## SERVICE LETTER 248

### Water Deflection Panel (Bulkhead #17) Reinforcement

<b>Aircraft Makes/Model(s):</b>	<b>Float Model(s):</b>	<b>Compliance:</b> Optional	<b>By:</b> MAS
Air Tractor AT-802 and AT-802A	10000A	<b>Part Number:</b> 1012082	<b>Approved:</b> DRH
		<b>Date:</b> 10/25/2022	<b>Revision:</b> C

Figure 1

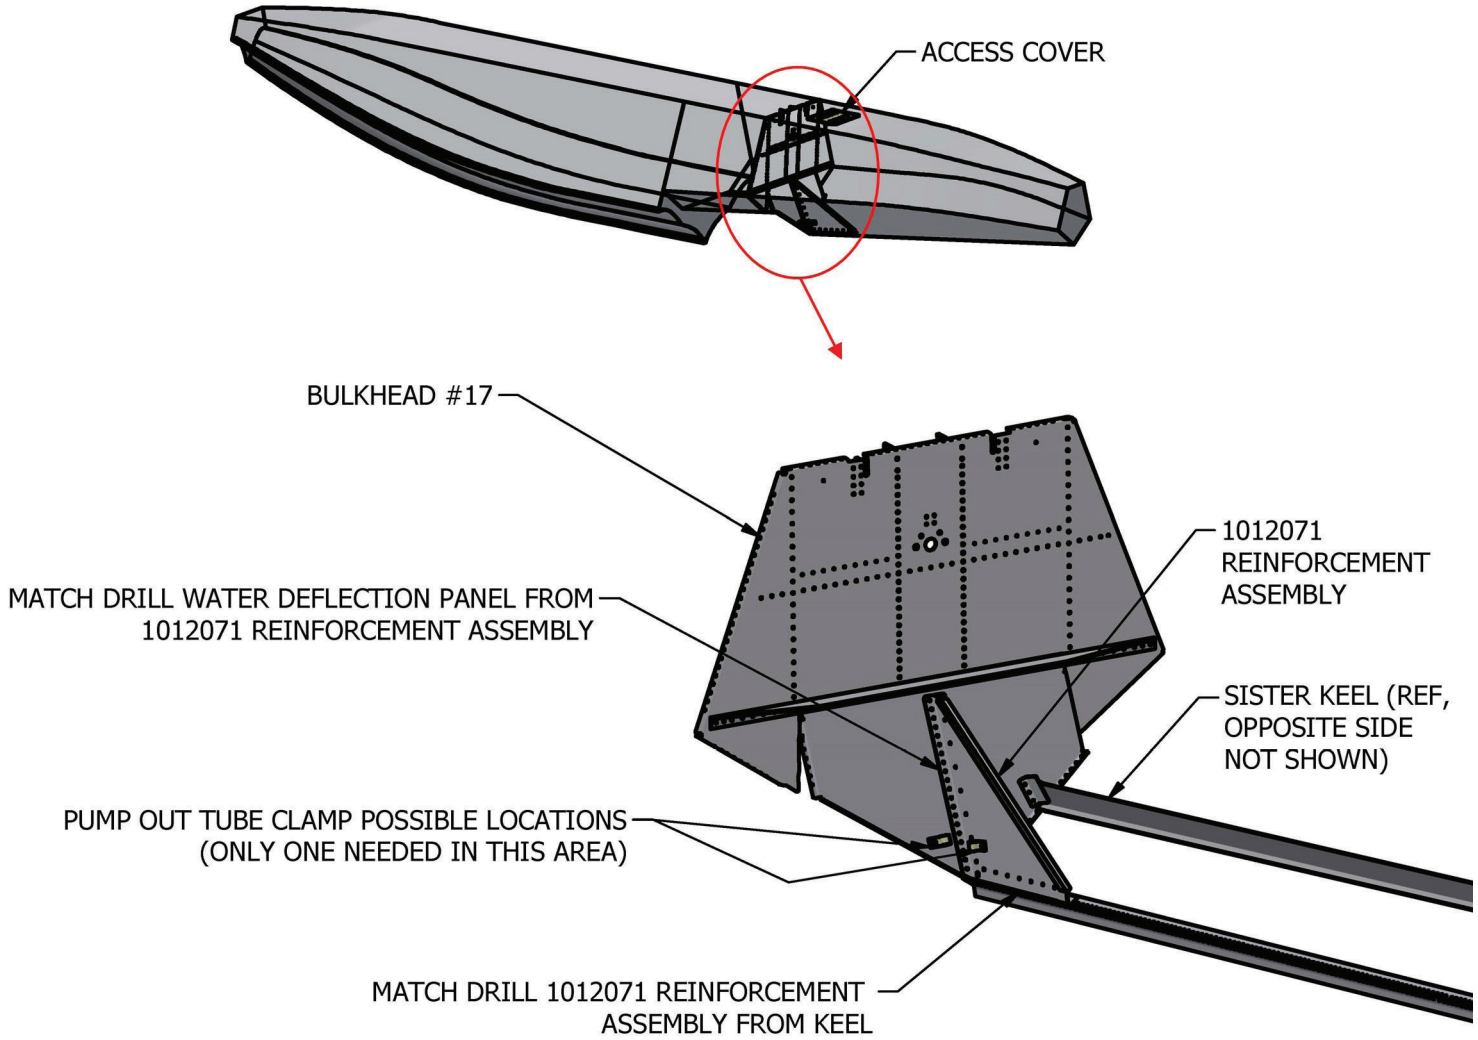
The water deflection panel (bulkhead #17, aft of wheel well) may experience deformation during water operations.

If the extent of deformation allows, install internal reinforcement assembly 1012071 (one per float) in accordance with the Work Instructions provided in this service letter.

1. Position and prepare aircraft for safe maintenance.
2. Remove top deck cover to gain access to bulkhead #17. See Figure 1.
3. Remove pump-out tube from bottom of float bay. Remove tube clip and plug rivet holes if clip conflicts with reinforcement assembly (if within ~1" of bulkhead centerline).
4. Remove rivets from keel between the flanges of bulkheads #17 and #18.
5. Remove sealant in the area as required.
6. Match drill holes from keel into reinforcement assembly 1012071.

**Note:** If the forward-most or aft-most keel rivet locations between the bulkhead flanges would violate 2D edge distance (ref: AC 43.13-1B) if placed in the reinforcement assembly, it is acceptable to trim the reinforcement assembly flanges to clear these rivets. Maintain the necessary edge distance for the adjacent rivet locations.

7. Match drill the vertical holes from reinforcement assembly into bulkhead #17.

**Note:** Given minor geometric variations, especially among early float serial numbers, it may be necessary to add aluminum shim(s) between the bulkhead and the mating flanges of the reinforcement assembly. Shims must be finished/sealed against corrosion and trapped moisture.

8. Remove parts and debur all new holes.
9. If the pump-out clip was removed in step 3, it may be relocated to the reinforcement assembly at this time, if desired.
10. Install assembled pieces using PR-1422 (or equivalent) at contacting surfaces and MS20470AD5 rivets.
11. Edge seal the installed reinforcement assembly and prime as needed.
12. If removed in step 3 and not already relocated in step 9, relocate the pump-out tube clip. The clip may be located on the new reinforcement parts or on bulkhead #17 (as before). Install the pump-out tube.
13. Reinstall top deck access cover.
